Re: Petition No. 1339 – Petition of Wallingford Renewable Energy LLC for a Declaratory Ruling that no Certificate of Environmental Compatibility and Public Need is Required for a 19.99 MW AC Solar Photovoltaic Electric Generating Facility in Wallingford, Connecticut

Petition No. 1339

**WALLINGFORD RENEWABLE ENERGY LLC'S RESPONSES TO
THE CONNECTICUT SITING COUNCIL'S FIRST SET OF INTERROGATORIES
RELATED TO THE DEVELOPMENT AND MANAGEMENT PLAN**

Vernal Pool Habitat Areas VP-2A

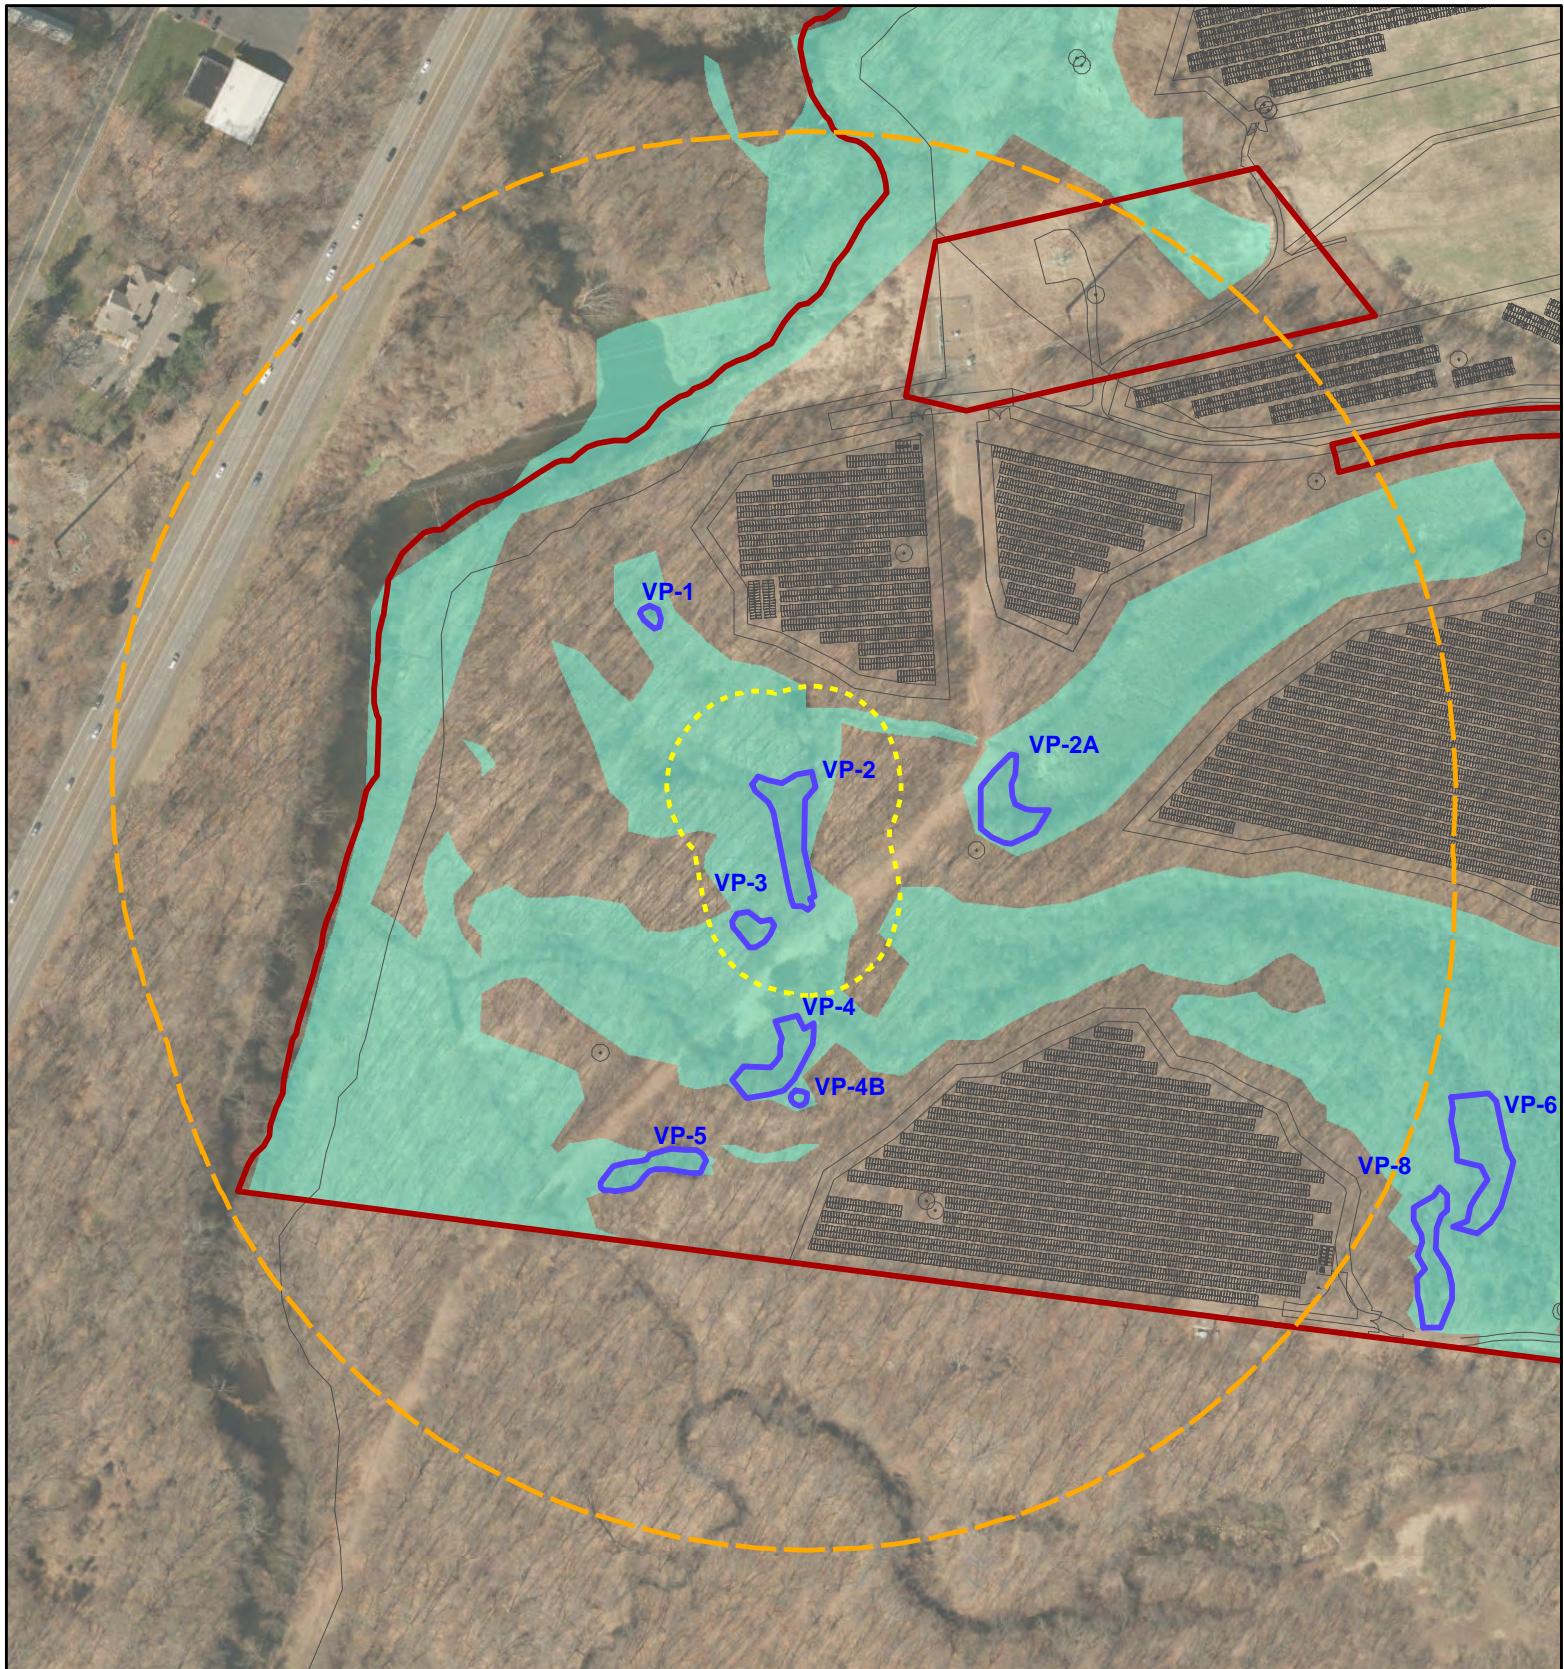
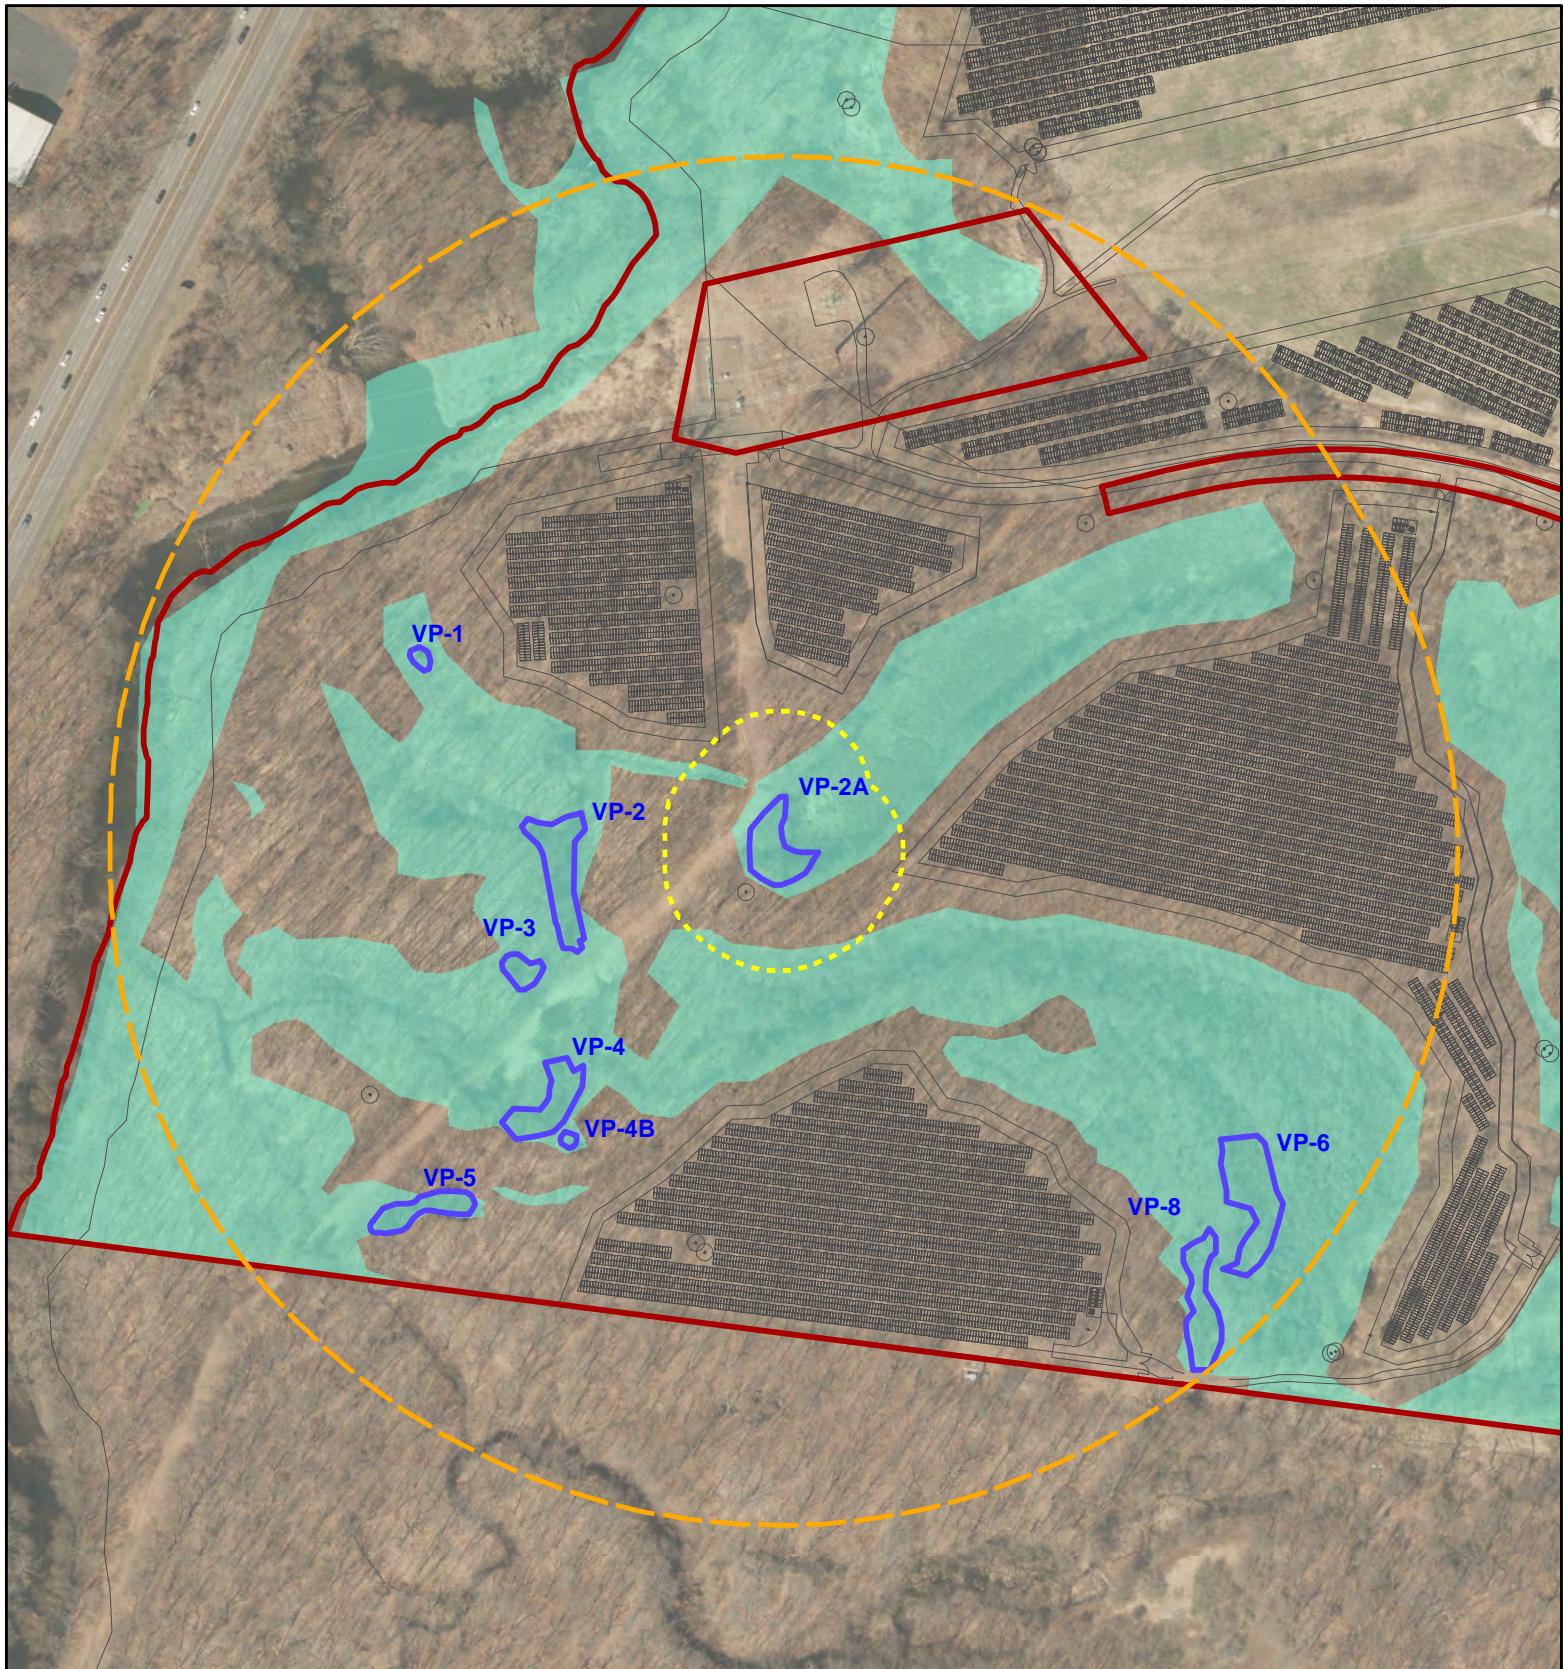
7. Referencing the Vernal Pool Survey Report (VPSR) dated June 14, 2018 and in light of the updated solar panel configuration (e.g. changes to Array PD1 on the east side), would Table 1 (on page 16) and Table 2 (on page 17) of the VPSR be materially affected? If yes, provide updates to those tables.

The Project's layout has remained predominantly the same within the vernal pool buffers, with the exception of the arrays located on the MIRA Parcel just north of VP 2A. In this location, what was two separate arrays has now been combined into a single array. The adjusted layout has been evaluated (adjusted figures are provided in Attachment D), and it has been confirmed that no change in impact to vernal pools or the 100-foot Vernal Pool Envelope will occur.

Impact within the Critical Terrestrial Habitat (CTH) buffer will change slightly as a result of the consolidated panels, but not in a material manner. The table below illustrates that CTH impacts are less than or the same as those reflected in Petition 1339, upon which the determination was made that habitat would be adequately protected.

DRAWING TITLE: MEDIUM VOLTAGE ROAD CROSSINGS

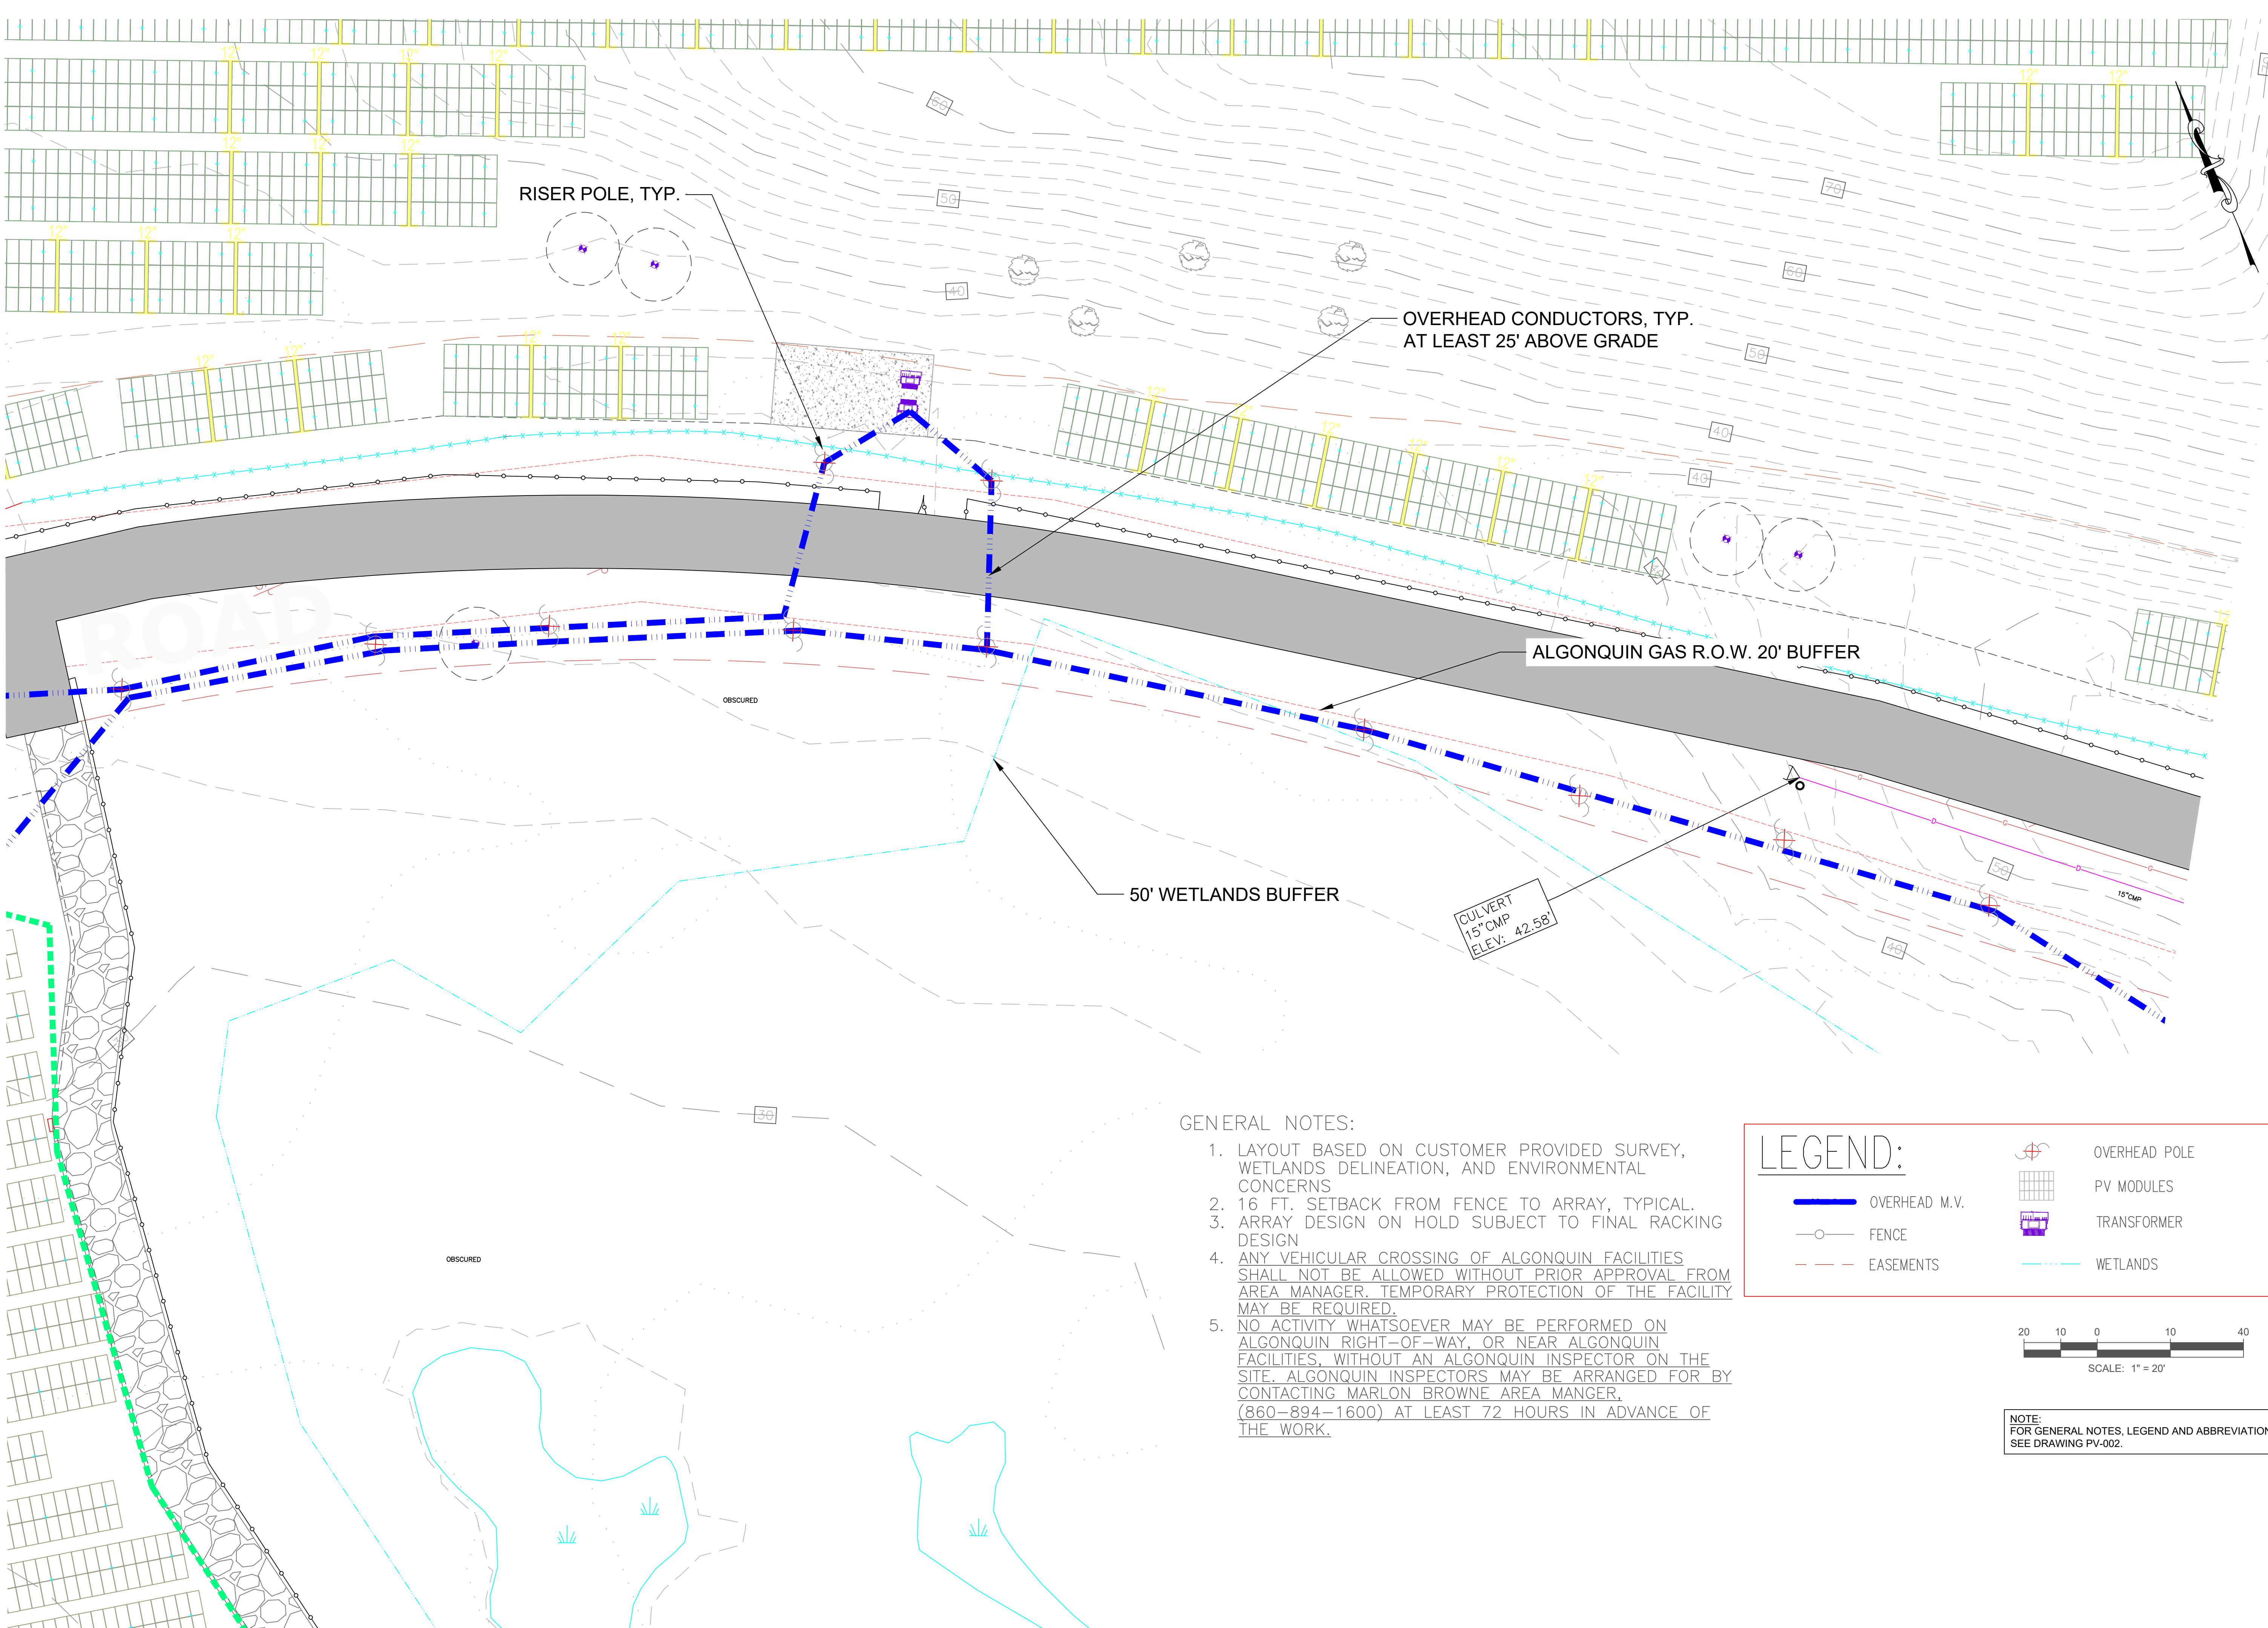
3. Condition No. 1(a) of the Council’s Declaratory Ruling requires the “electrical interconnection.” Sheet PV-40 refers to Electrical Interconnection Equipment Plans A through C and refers to Sheet PV-41 and PV-42. Provide a copy of Sheet PV-41 through PV-45. How many new wood poles would be installed to accommodate the interconnections (e.g. 150)? Approximately how tall would such poles be above grade? Referencing Sheet PV-40, does “medium voltage” refer to approximately 13.8-kilovolts for this project or a different line voltage?

Please see Sheets PV-41 through PV-45 included with this response. There are approximately five new wooden poles per Point of Interconnection (15 total) would be installed to accommodate electrical interconnection. The poles will be approximately 45 feet high. The medium voltage referenced in PV-40 is 13.8-kilovolts. An additional 105 wooden poles for overhead medium voltage line will be required within the site.
